# 24 SUB2008-00120

## MCNEIL SUBDIVISION

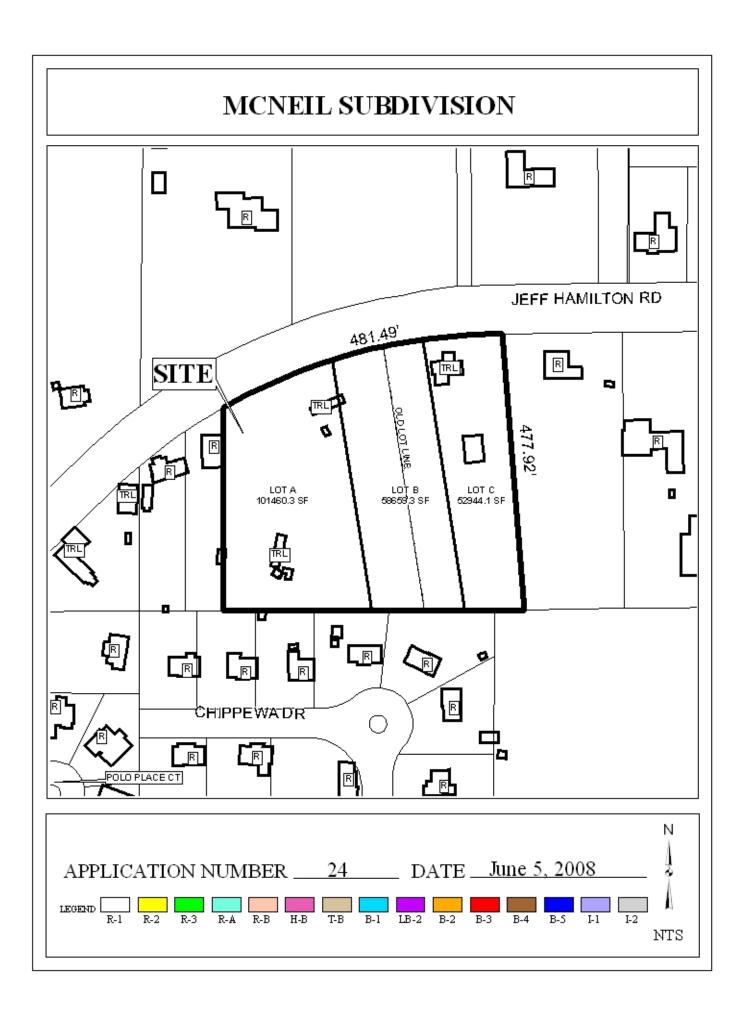
According to Section V.D.3 of the Subdivision Regulations, the maximum depth of any lots shall not be more than 3.5 times the width of the lot at the building setback line. While proposed Lot A does meet this requirement, proposed Lots B and C do not meet this requirement. After research, staff was unable to find any legal lots in the immediate vicinity that do not meet this requirement therefore, the application should be denied or redesigned so that each lot meets the width to depth ratio.

The plat is recommended for Holdover to the July 3 meeting, with revisions due by June 19<sup>th</sup> to allow the applicant to address the following:

- 1) Redesign each lot to meet the width to depth ratio; or
- 2) Provide justification for waiver.
